**MONTGOMERY COUNTY HISTORIC PRESERVATION COMMISSION**  
**STAFF REPORT**

<b>Address:</b>	46 Philadelphia Ave., Takoma Park	<b>Meeting Date:</b>	12/20/2023
<b>Resource:</b>	Contributing Resource <b>Takoma Park Historic District</b>	<b>Report Date:</b>	12/13/2023
<b>Applicant:</b>	David Bates & Anne LeVeque Brian McCarthy, Architect	<b>Public Notice:</b>	12/6/2023
<b>Review:</b>	HAWP	<b>Tax Credit:</b>	Partial
<b>Case Number:</b>	1051682	<b>Staff:</b>	Dan Bruechert
<b>Proposal:</b>	Partial Demolition, Rear Addition, Fenestration Alteration, and Roof Replacement

## TREE PROTECTION PLAN

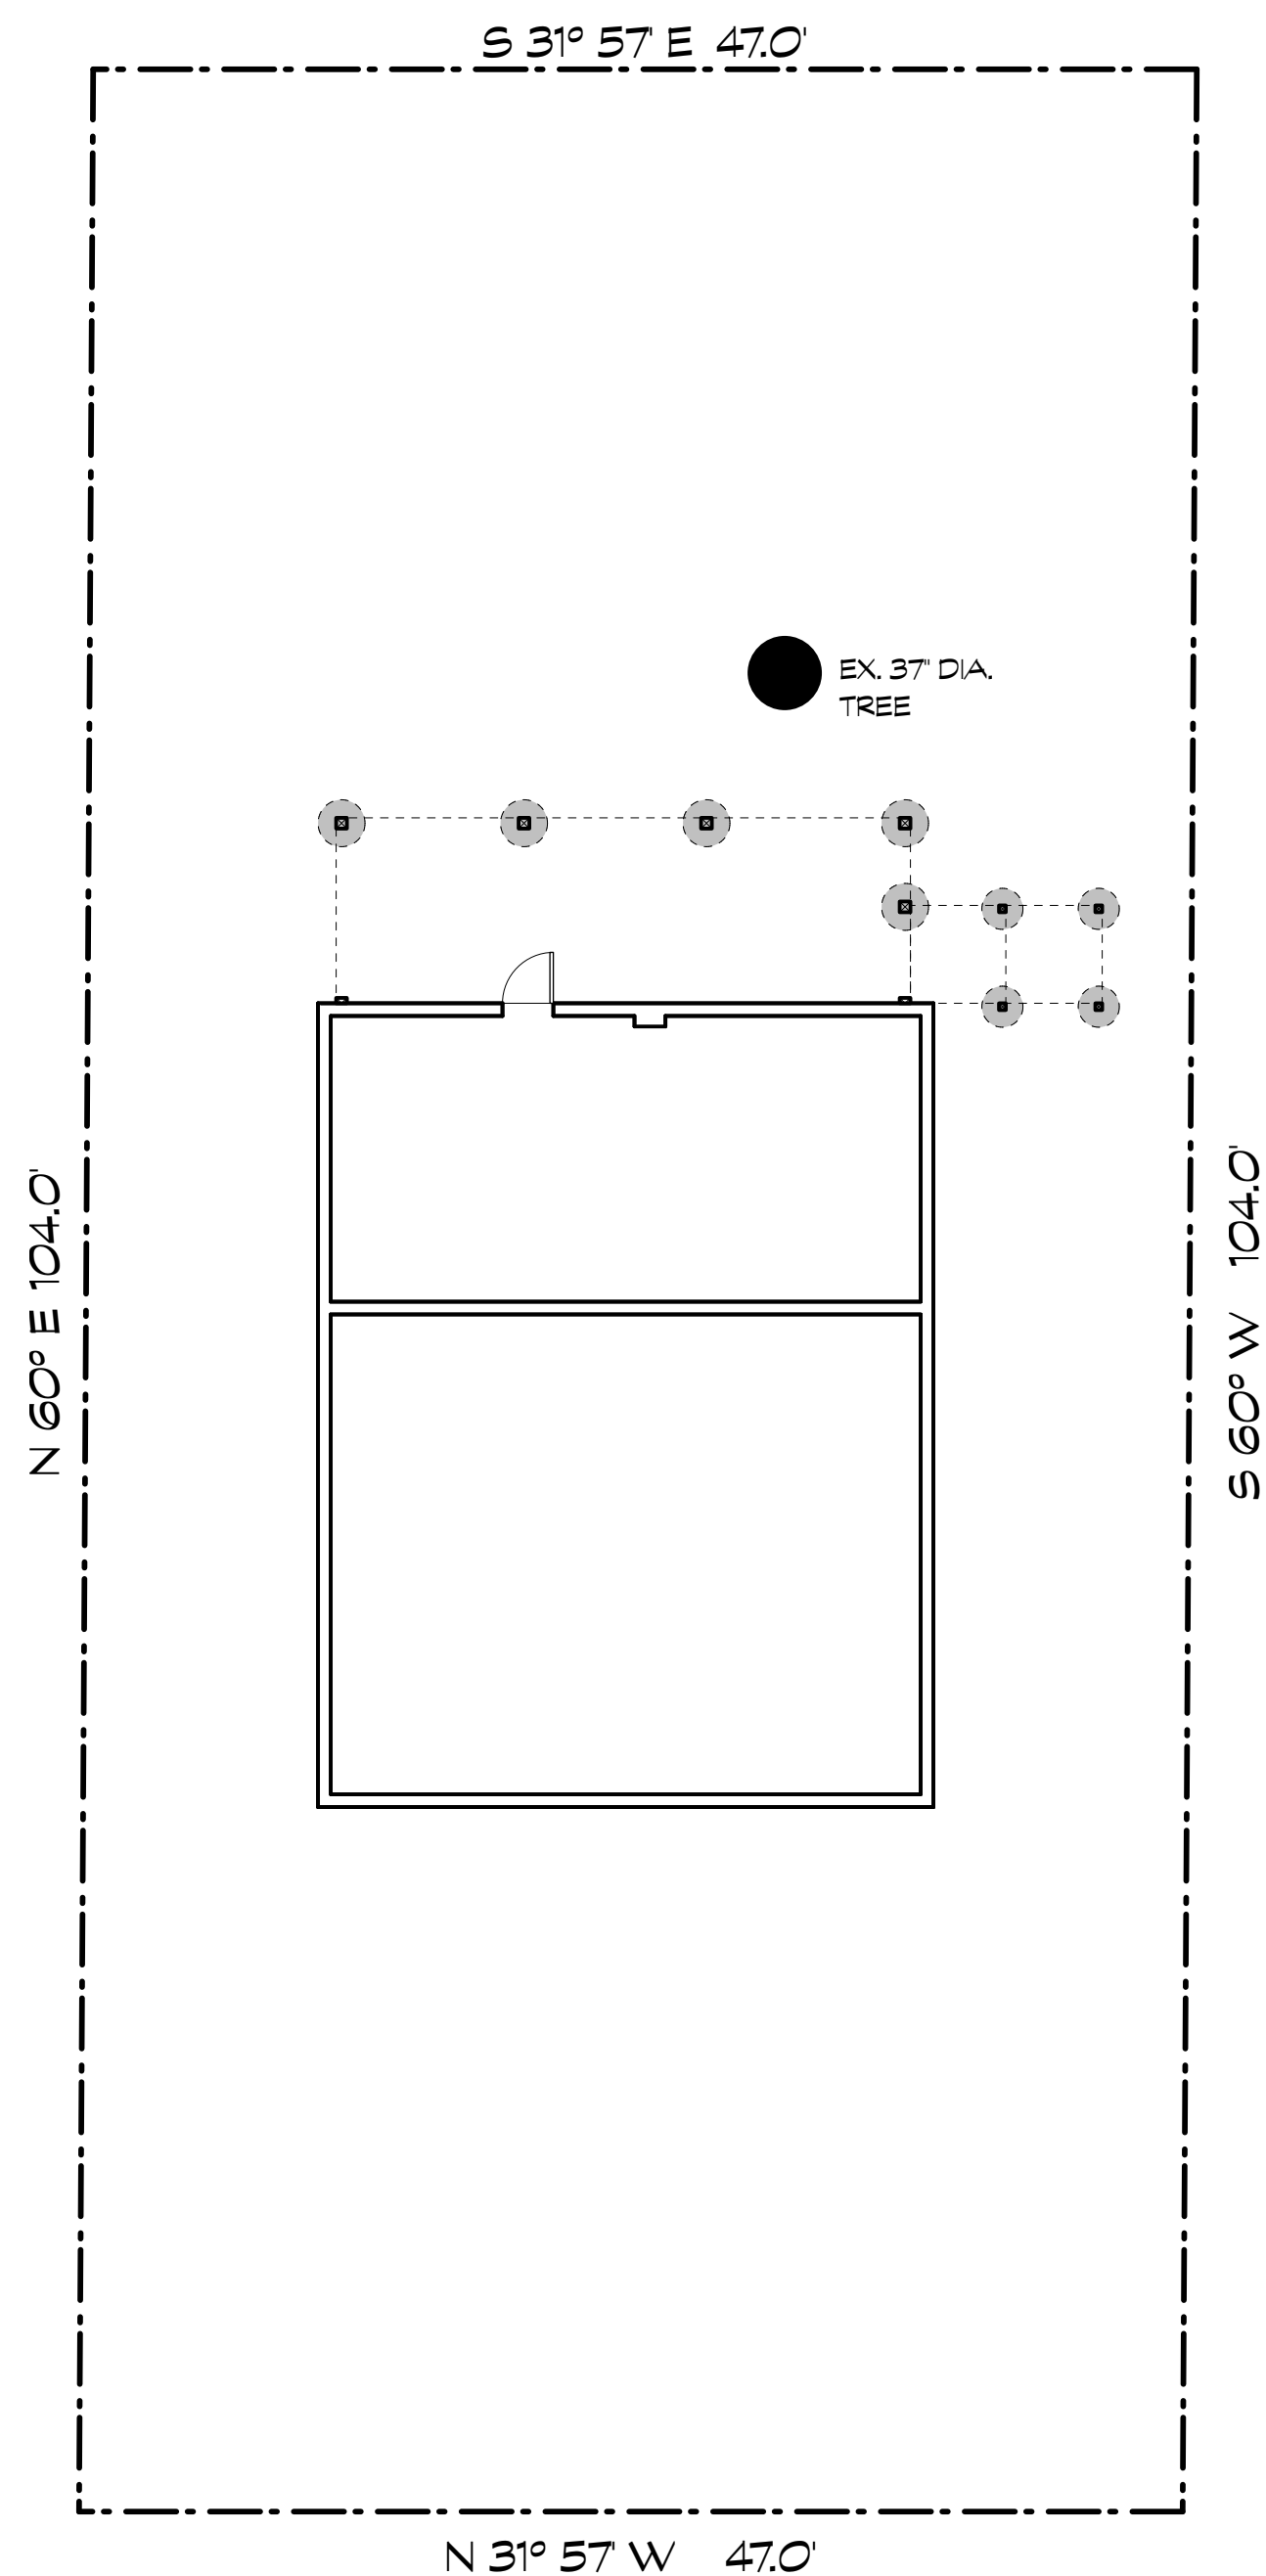
While the proposal is generally compatible with the District, the application is missing several details regarding materials, tree protection, and there is information missing from the drawings. In particular, the tree protection plan measures, while shown in the Key on the cover sheet, are not detailed on the lot plan, nor is there an arborist's report accompanying the project. Staff has proposed several conditions asking for additional information and annotation of the plans prior to release of the approval.

1. An arborists report shall be submitted for review. Any recommendations for tree protection, staging and storing of materials, and all protective measures shall be shown on amended plan sheets as necessary.

**A100**

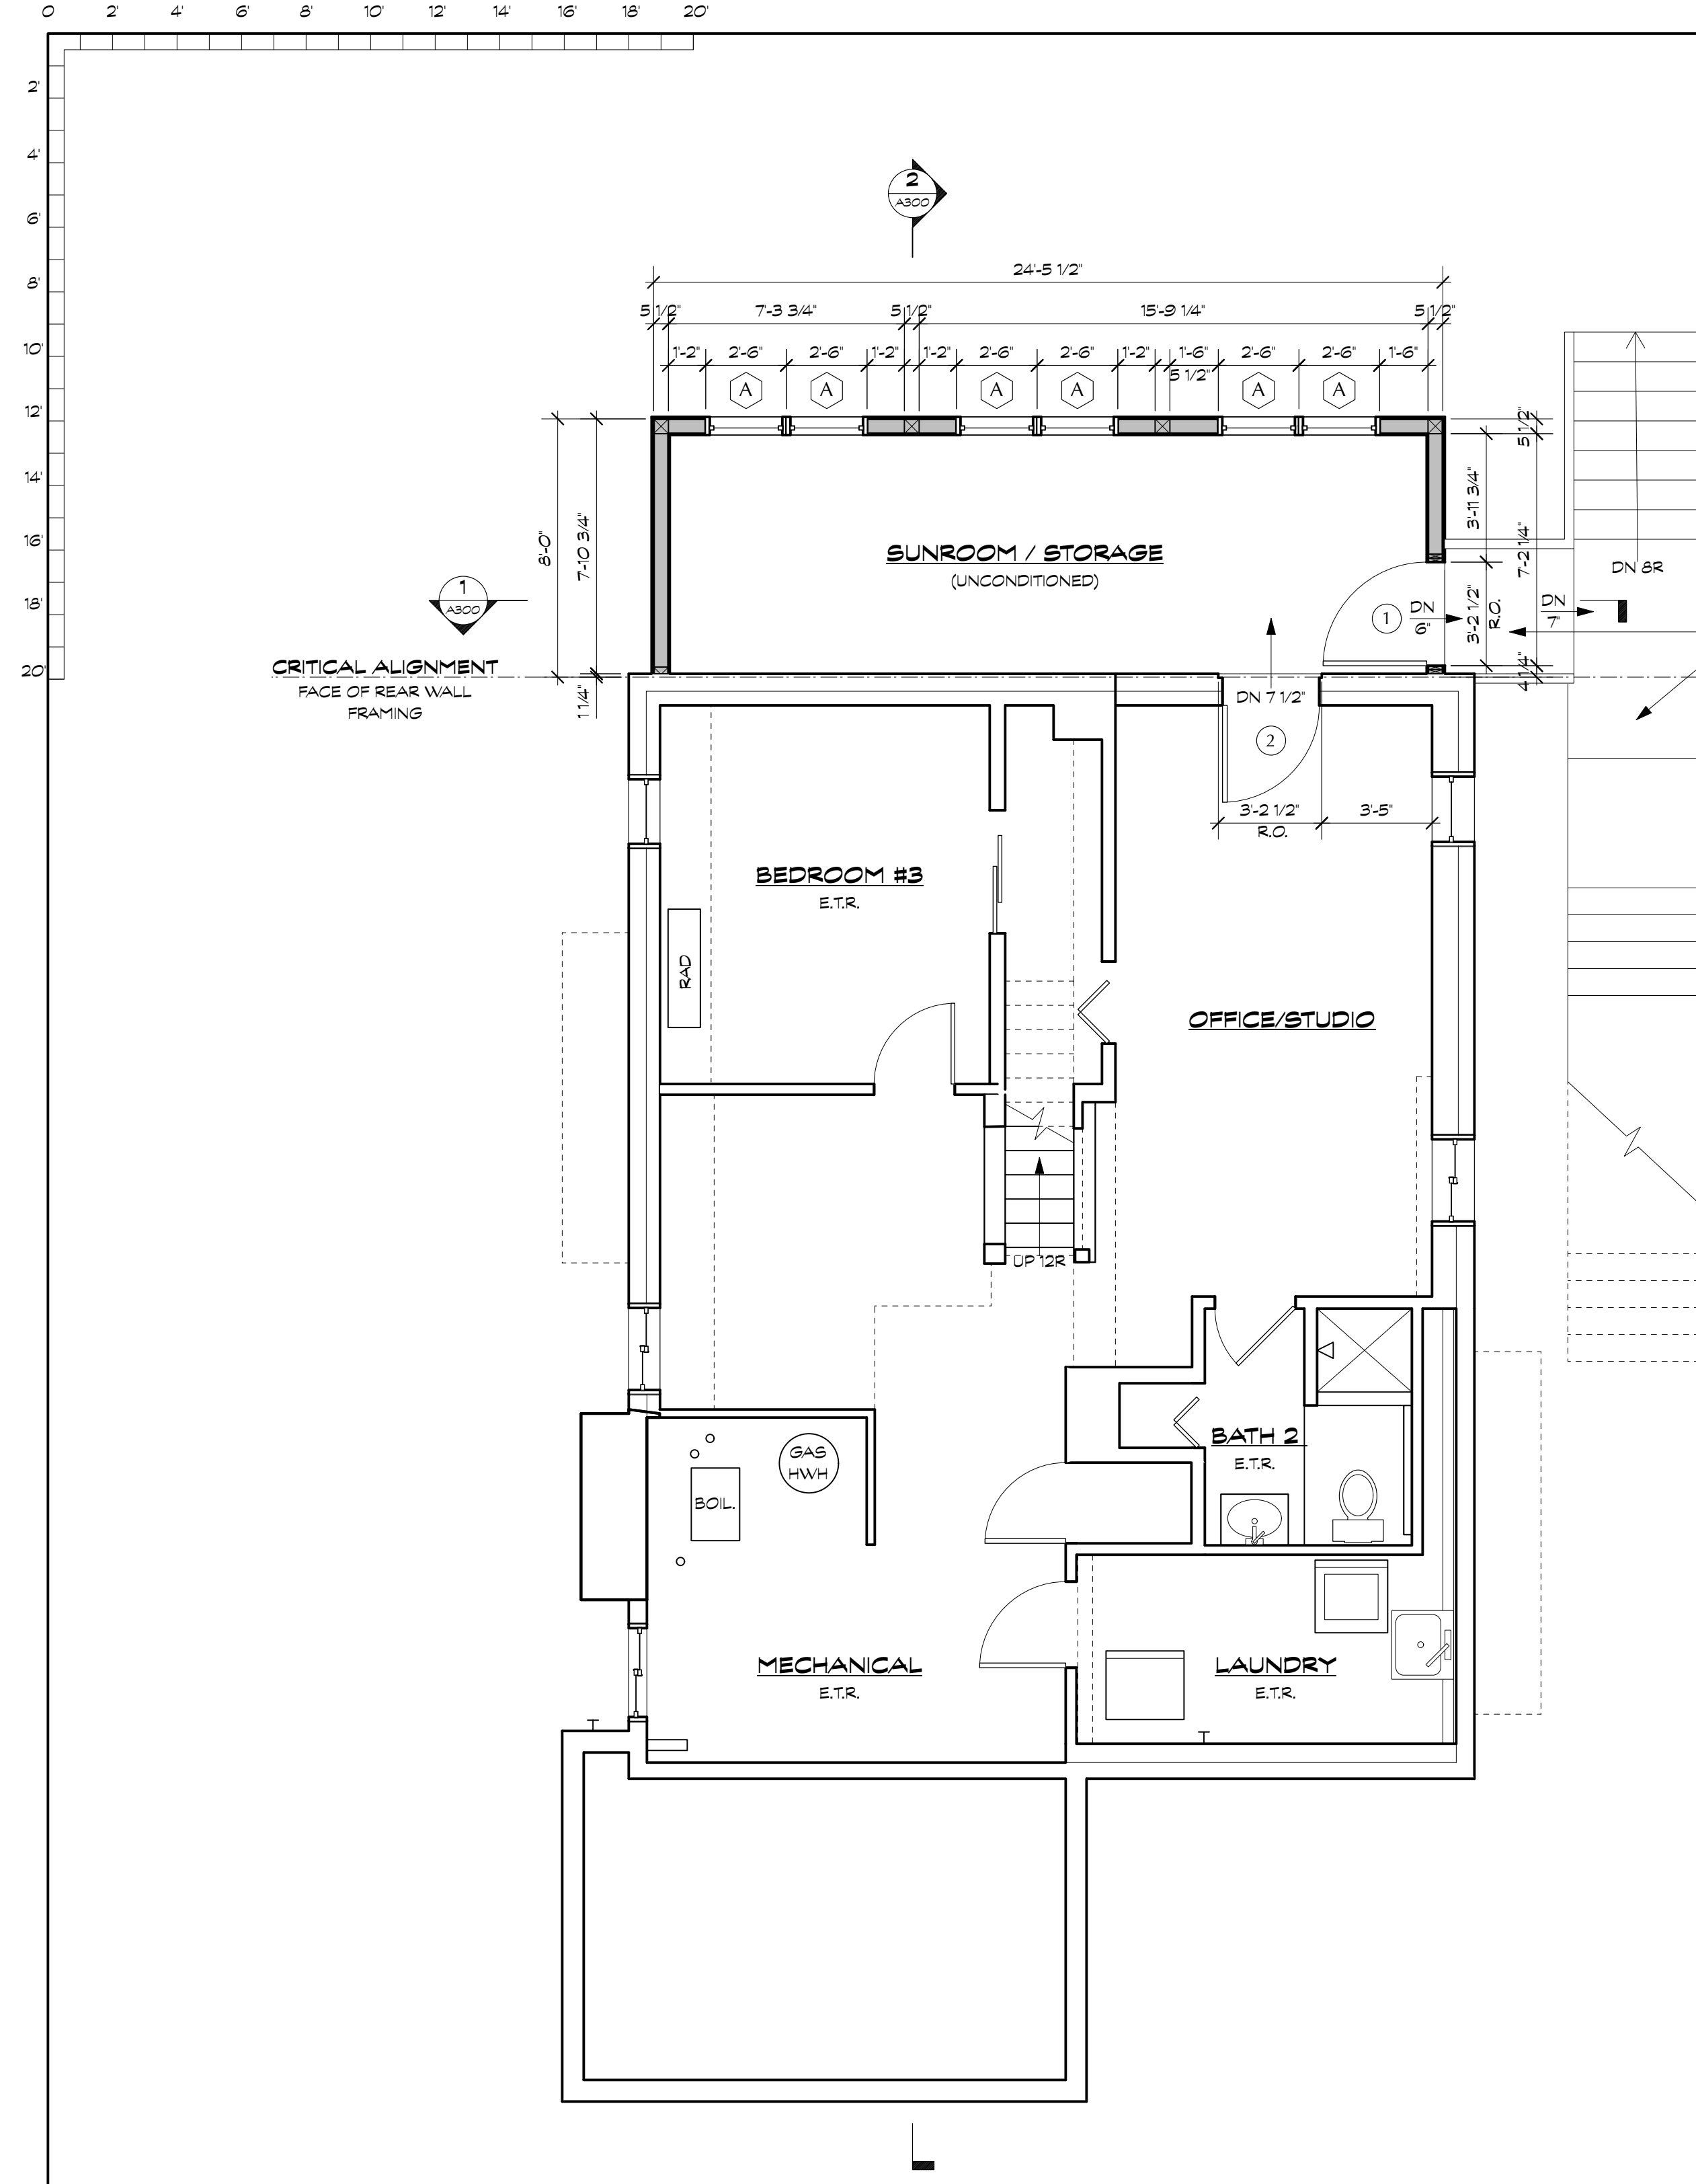
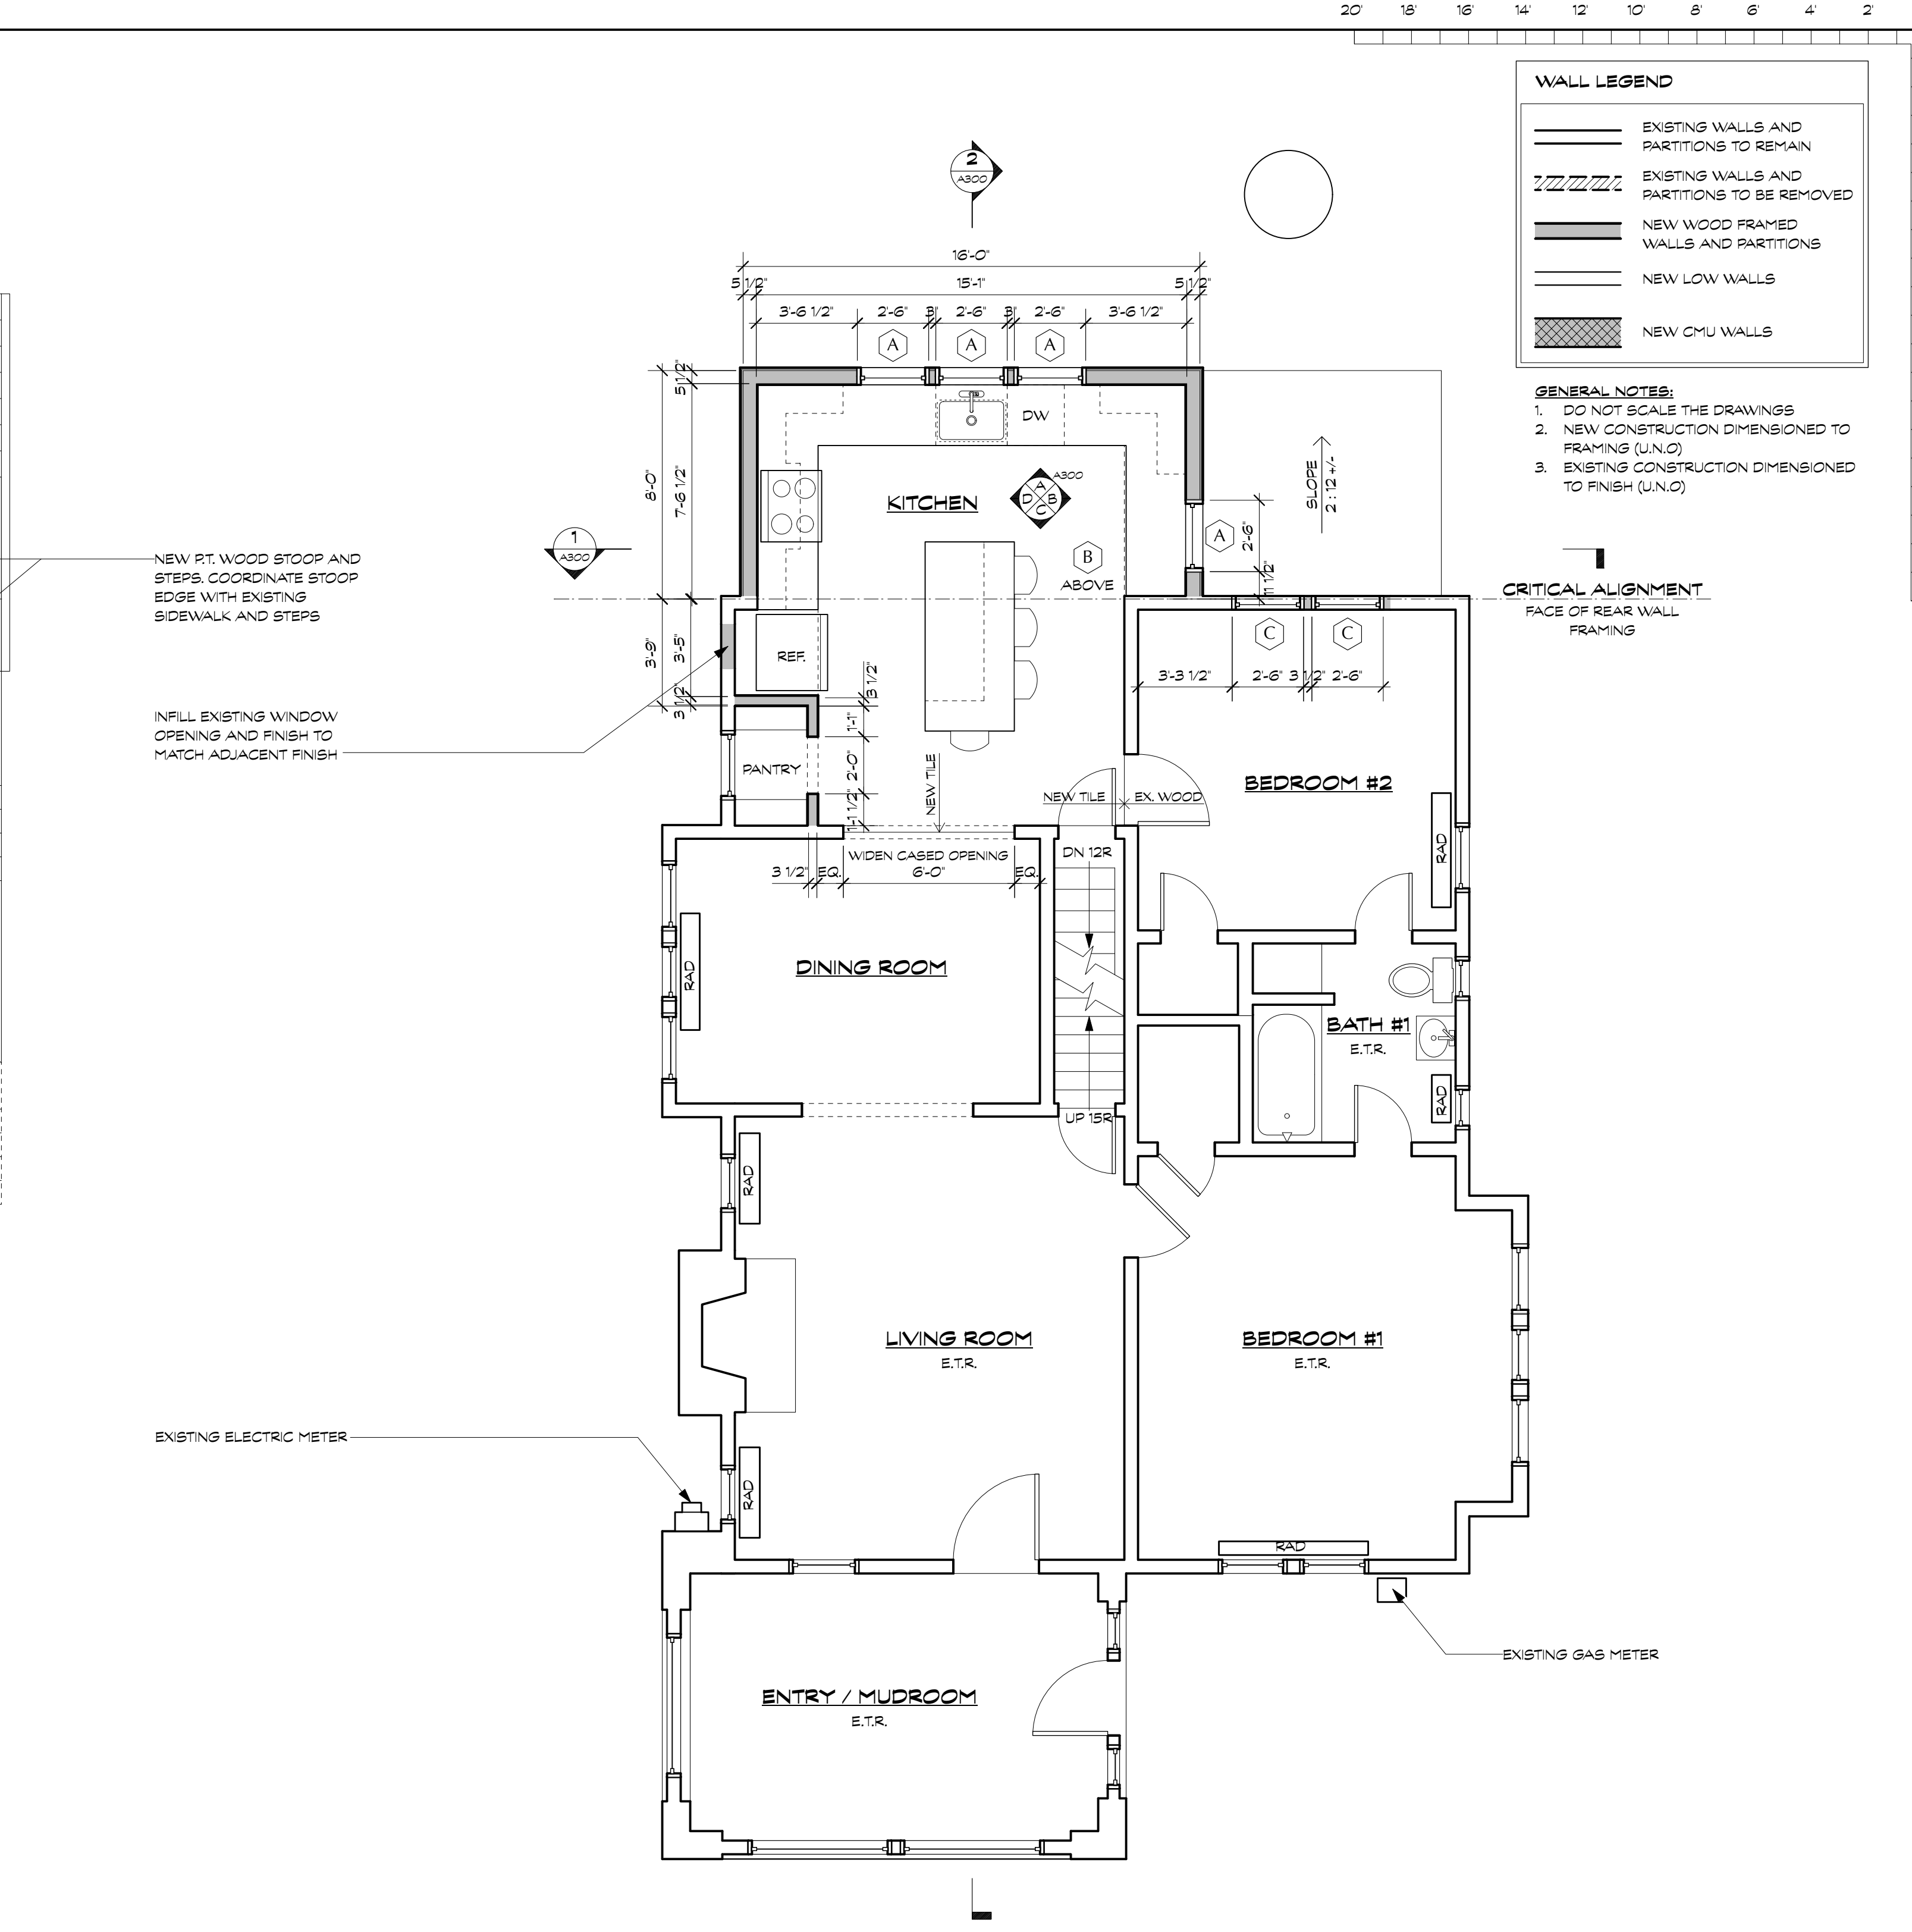
3. Window muntin dimensions shall be called out in a revised Window Schedule. Catalogue sheets denoting the muntin profiles, jamb, sill, and header details shall also be submitted.

6. All elevation and plan drawings shall be updated to note the porch and stair floorboards shall be wood or Aeratis. If Aeratis is chosen, specification sheets shall be submitted as part of the revised set of drawings.

7. All elevation and plan drawings shall be updated to note the handrail system shall be wood. If a substitute material is shown, specification sheets shall be submitted as part of the revised set of drawings and approval of the material is delegated to staff.
